## **Appendix FEIR-1**

Draft EIR Comment Letters

Subject: ICON Sherman Oaks  
SCH#: 2014071001

Alternative 5: Reduced Density and Square Footage

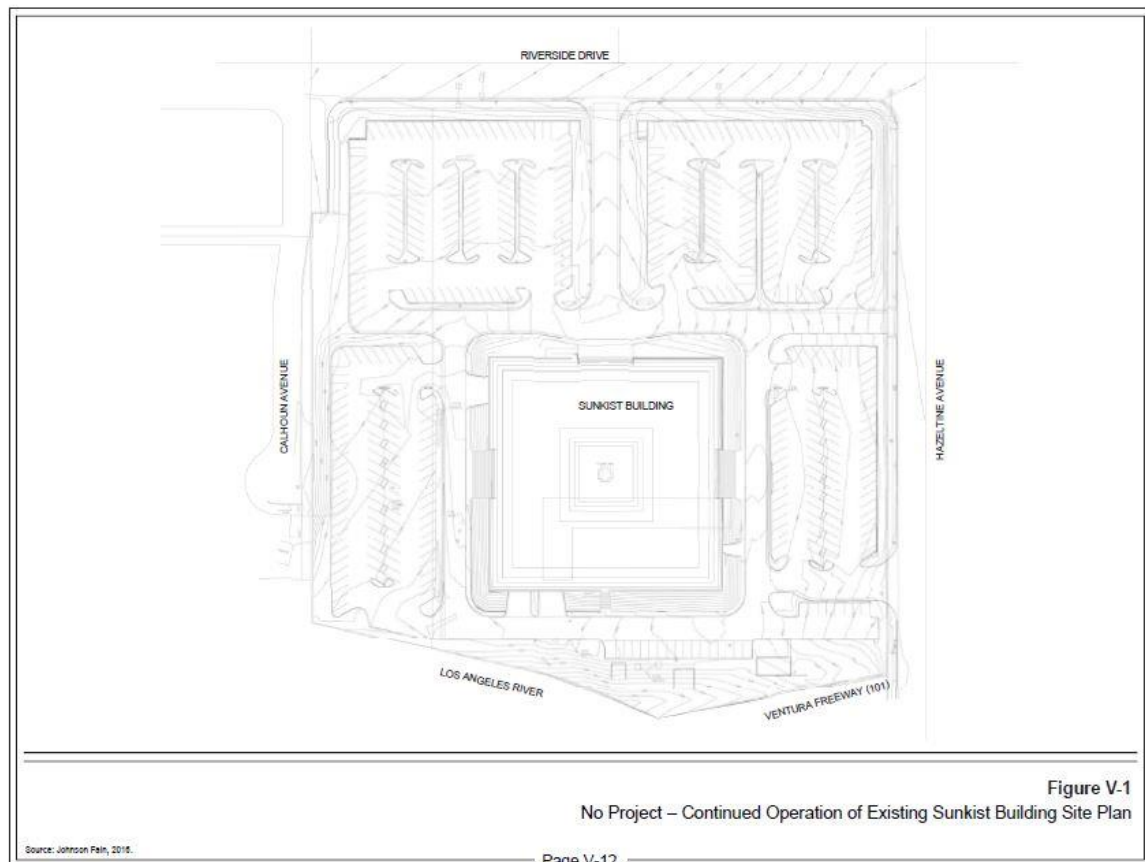
Comment: A Reduced Density Alternative should have the square footage based on something. We recommend basing the square footage on the amount of parking that is in keeping with the existing PB-1L zoning.

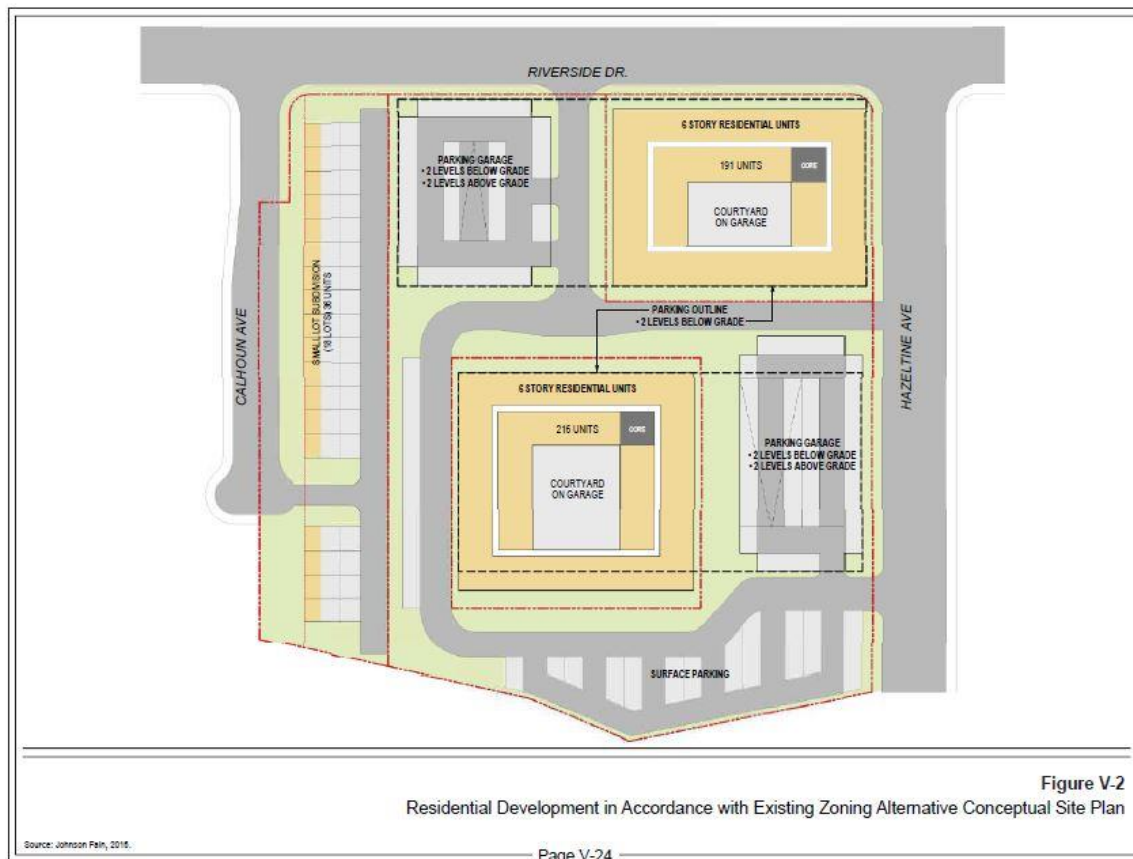
Comment: There is no Alternative showing a scheme based on the current zoning, a "by right" scheme.

The current zoning allows for an increase in the development of the site. To properly understand the applicant's request the public needs to understand the difference between the requested development and what is currently allowed. The alternates should demonstrate conceptual differences, not just variations on the proposed project.
